# Certificate of Appropriateness

**Property**                    **2424 N. Grant Boulevard**

**Description of work**    Wood fence per attached plans.

**Date issued**                2/17/2026

Fence design

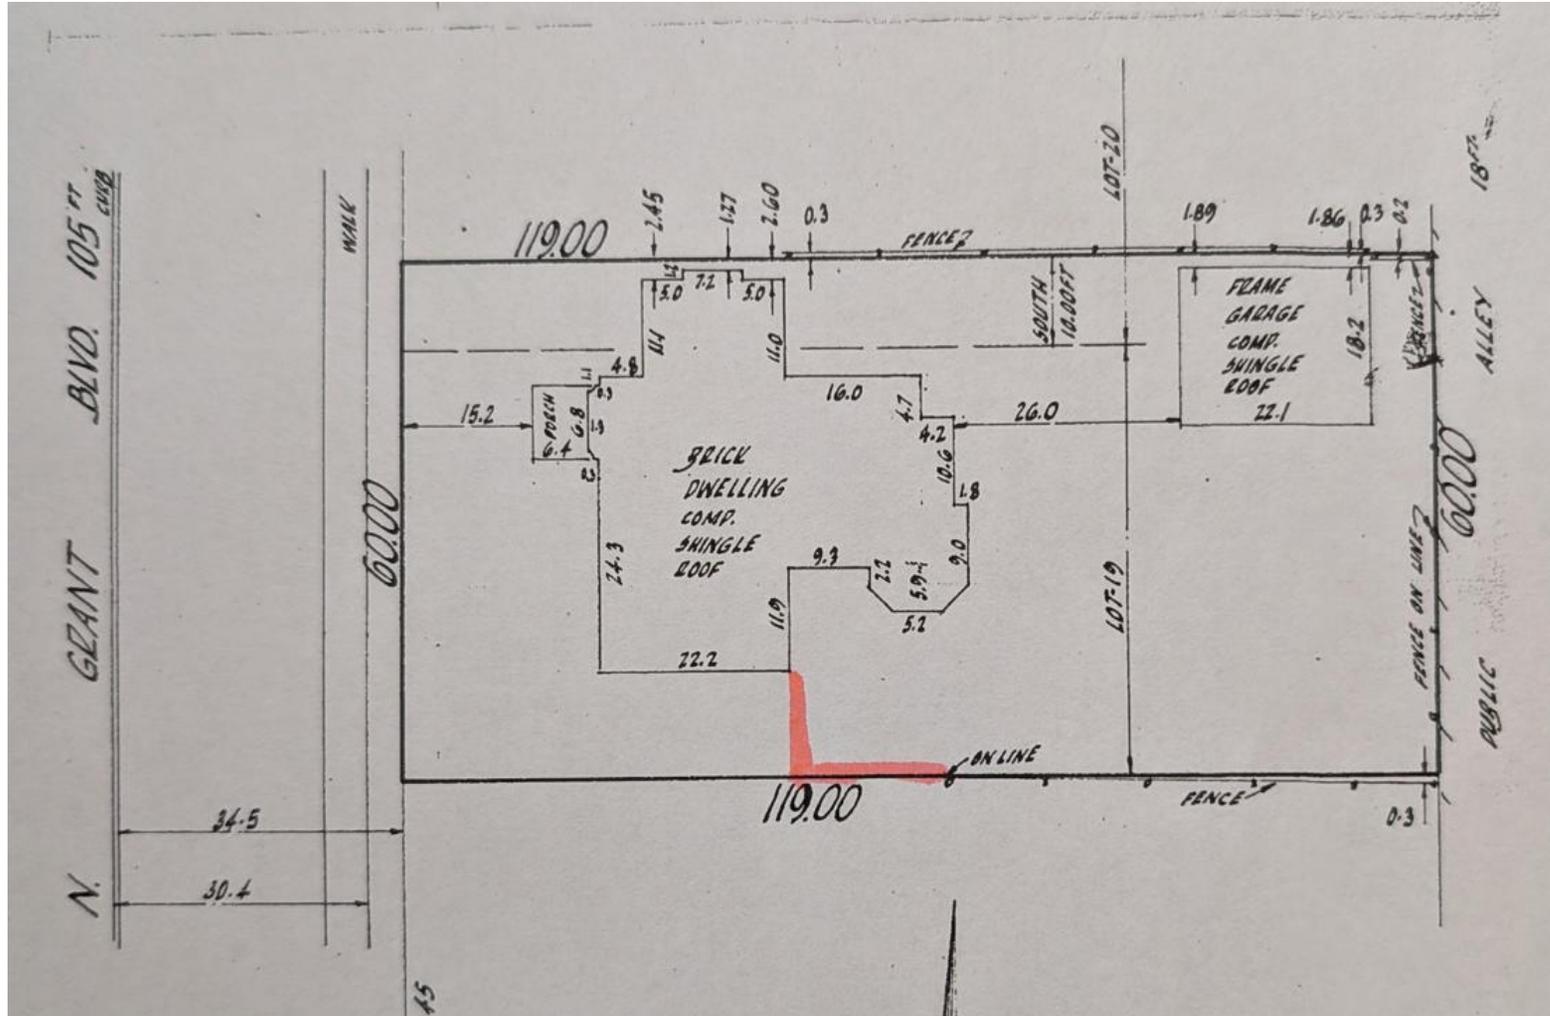
All wood must be smooth and equivalent to #1 grade cedar or better for use in rear and side yards. Sections of fence forward of or in line with the primary building's front setback must be clear grain. Wood fences must be painted or stained upon completion. Note: when new, bare wood is left exposed to the exterior elements for a period of only a week or two, the life of the finish subsequently applied to it will be decreased.
